## Construction Completion Report

BRIO Lofts (Solterra Property)  
3912 North Vancouver Avenue  
Portland, Oregon 97227

ECSI #6219

October 7, 2022 (Revised February 20, 2024)

SHEET ID  
**C02**

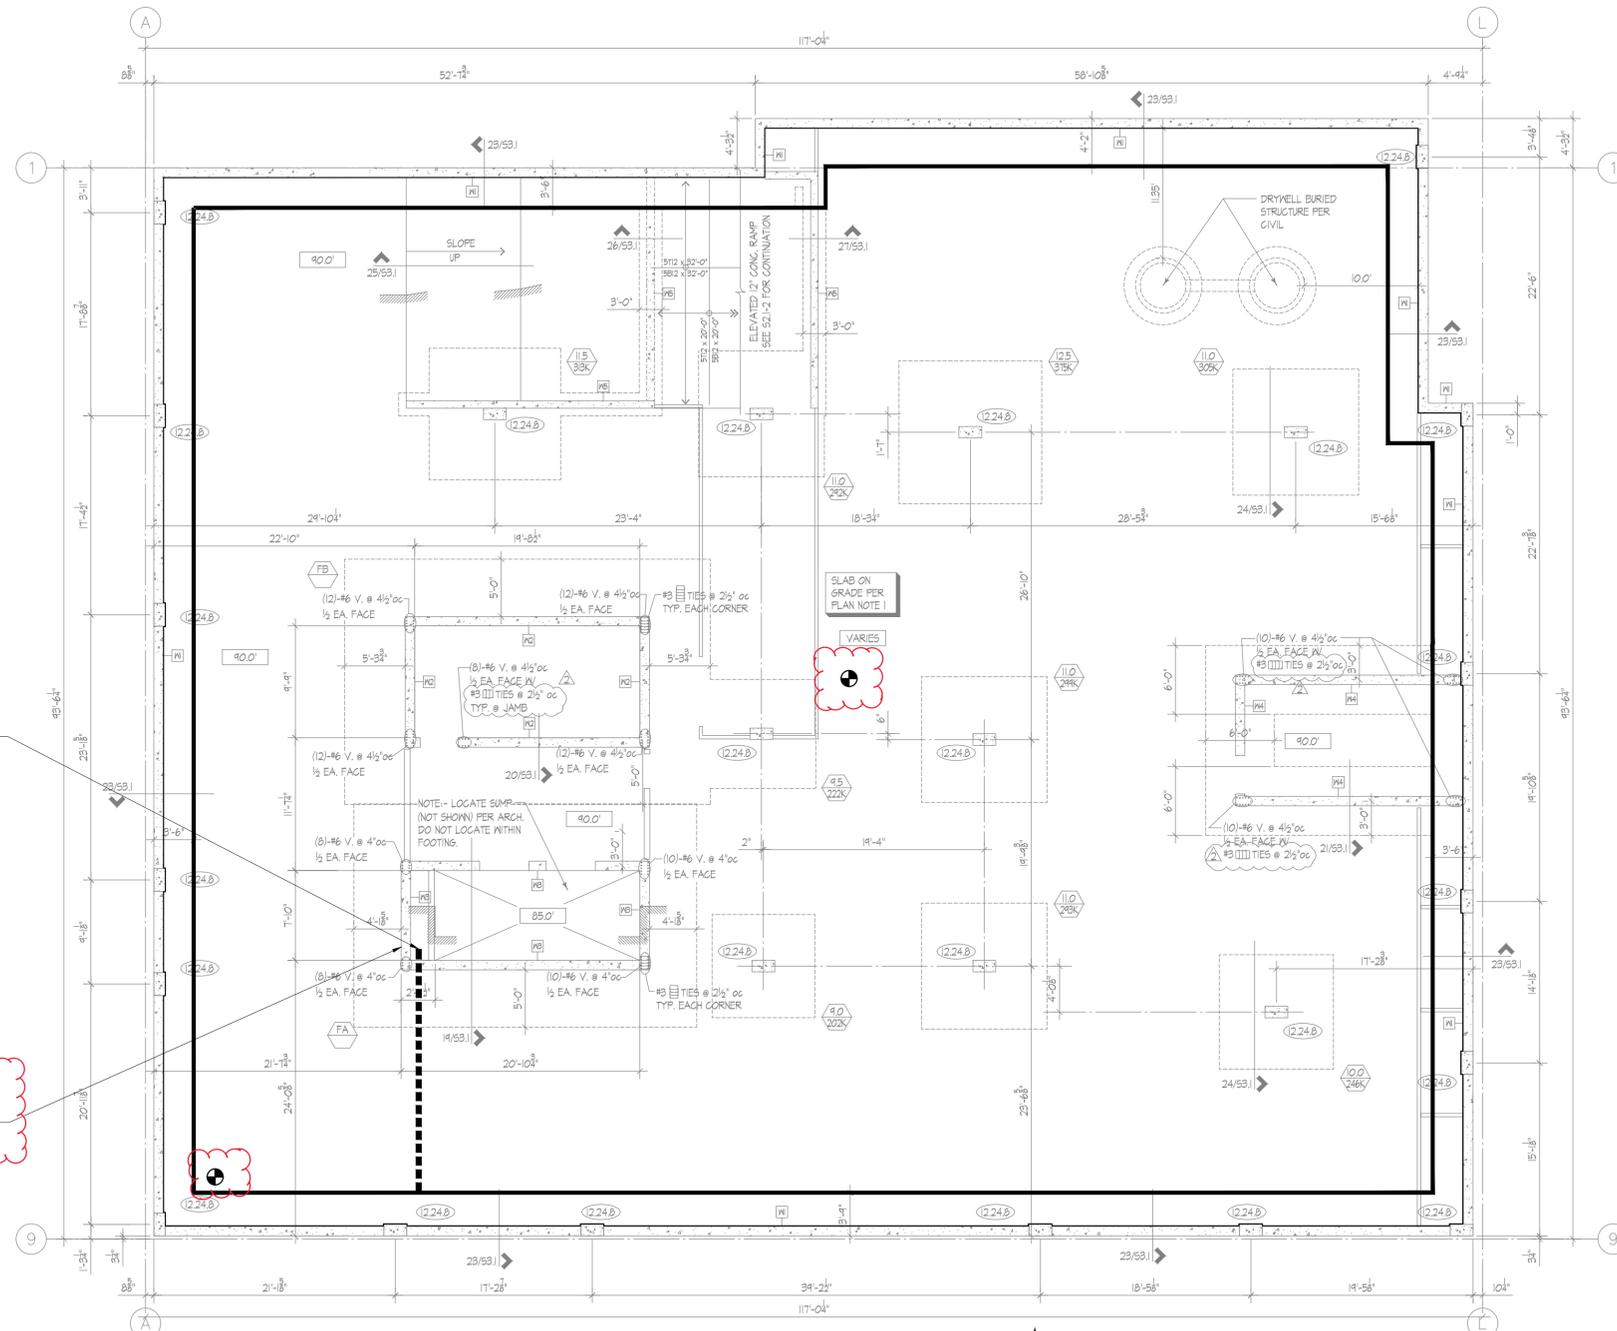
-Figure 2. It is difficult to assess whether the interior vapor point is located in the most vulnerable portion of the building since the first floor layout is not provided. If there are no enclosed spaces where vapors are likely to be trapped, then this central location may be acceptable, however insufficient information is provided.

7. Figure 2 is labeled as "For Reference Only". Design drawings should be submitted to DEQ for review and approval. All final drawings will need to be stamped (and signed) by an Oregon registered professional engineer.

Vapor points are being installed on the lower level parking garage using vapor pins, which are a permanent installation. Figure 2 shows the locations of the vapor points. The figure has also been updated to show the lower level foundation plan. Previous comments about interior vapor points on the first floor are not applicable.

These plans were not prepared by PBS. PBS only used the existing building footprint to provide design details for their portion of this project. In the General Notes section of Figure 2, it indicates the original figure was provided by Visser Engineering Company and the figure is used to show layout of depressurization system. Legacy notes have been removed from drawings submitted to DEQ.

**SAMPLING PORT DETAIL**

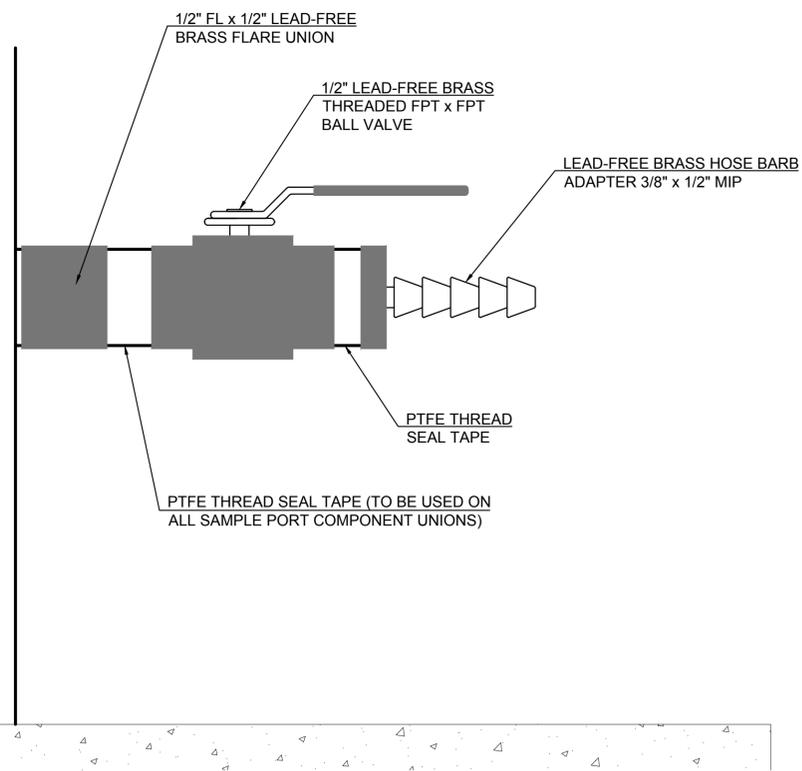
-SOP for sub-slab vapor and soil gas sampling. The SOP and text of the plan indicate sampling will be from sub-slab points. However, Figure 3 shows sampling from a vapor port connected to the pvc piping underground in addition to the two sub-slab points. Please clarify. For samples analyses, please analyze the samples for TPH-G and VOCs by EPA Method TO-15 as earlier discussed. Please ensure that the lab can meet DEQ's soil gas screening levels.

**ROOF VENTING LOCATION DETAIL**

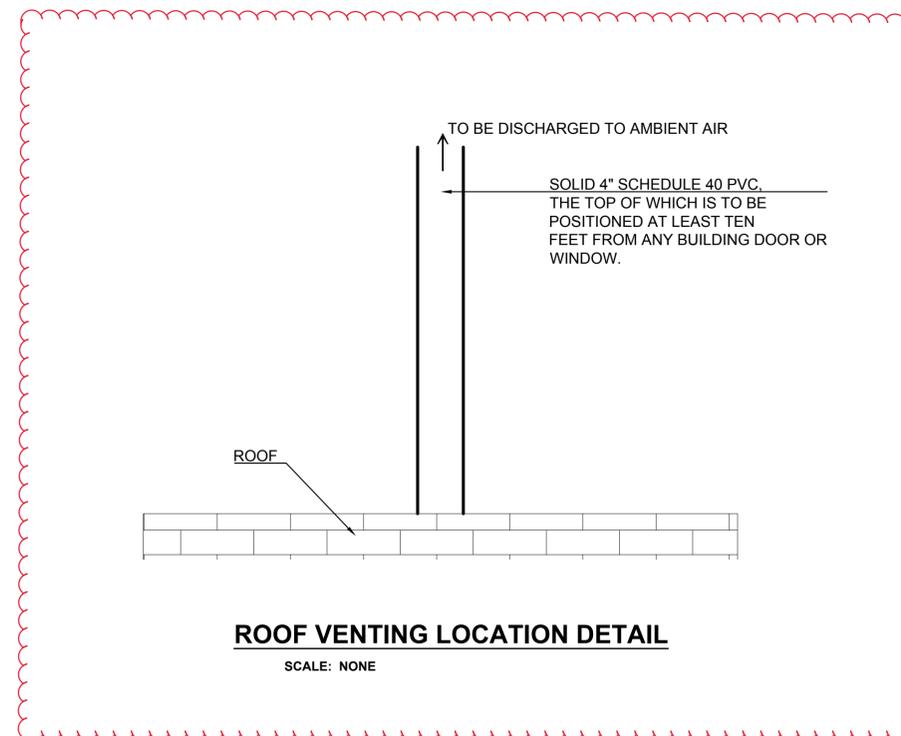
6. Figure 3. A detail should be provided showing the offset and height requirements for the vent riser

Offset and height requirements are stated in the Roof Venting Location Detail on Figure 3.
